Overview: The initial production release of the FTI-TLK1 harness has an issue where in some vehicles the secondary power input to the CN1 connector will overload the associated vehicle circuit, causing a fuse to blow. This issue affects the initial release of harnesses and is already being addressed in production. A field correction procedure is detailed below in Figure 1.

FTI-TLK1 Type 3B5 - Vehicle Coverage & Preparation Notes

FTI-TLK1 Type 3B5 - Installation Notes & Wiring Diagram

Figure 1: Step by step adapter correction

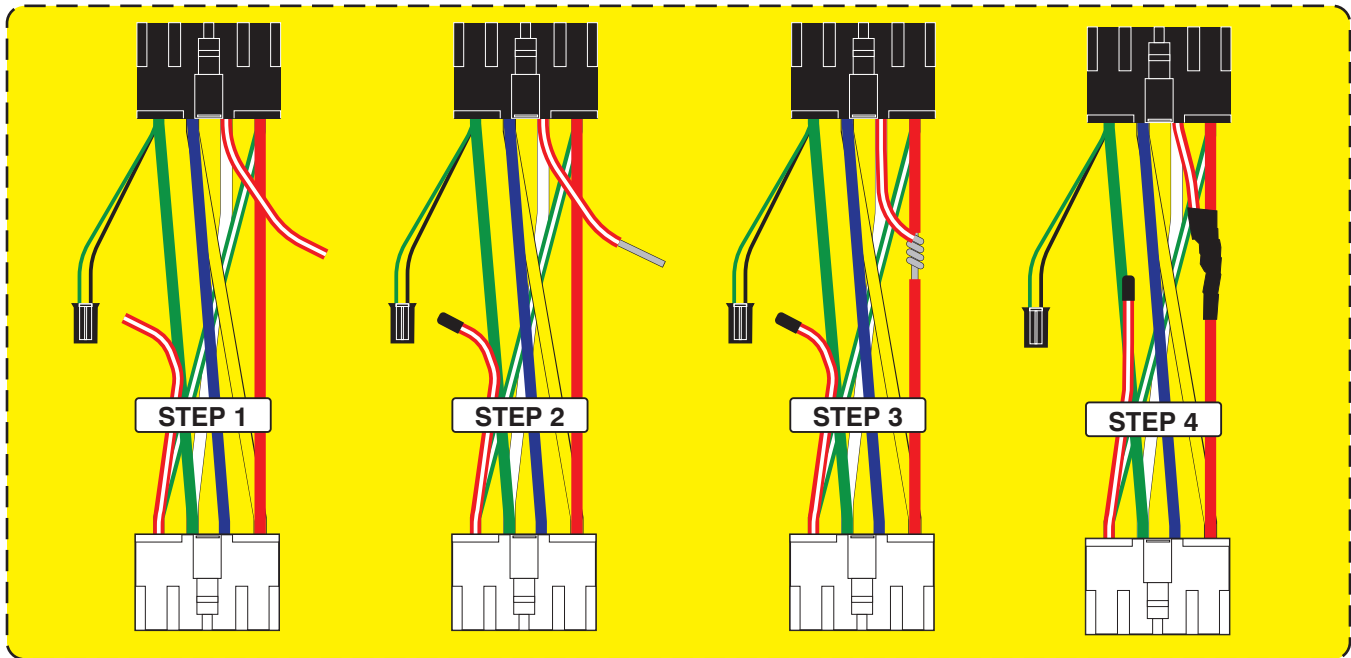
Issue: The secondary power circuit can overload some vehicle ignition switch circuits, causing a blown 5A/7.5A AM1 fuse, potentially disabling the vehicle and leaving the consumer stranded. Affected adapters are illustrated below in figure 2.

- 1.) Select the applicable CN1 adapter, isolate the RED/WHITE power wire, cut wire approximately 4" from the BLACK plug
- 2.) Insulate the wire still connected to the WHITE plug using heat shrink tubing, and strip the insulation on the other wire end
- 3.) Strip a portion of the insulation from the RED wire, attach the stripped RED/WHITE to the exposed RED wire, solder together
- 4.) Apply insulating tape to the soldered connection and secure the cut ends back to the bundle of wires created by the adapter
- 5.) Correction complete, you may safely proceed to finish your installation

Figure 2: Supplied CN1 Harness Adapters

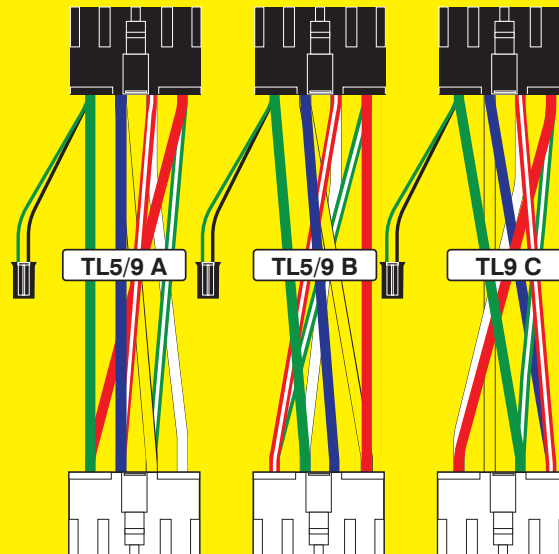
Incorrect power provisions with the potential to overload vehicle ignition supply circuit, resulting in blown AM1 fuse.
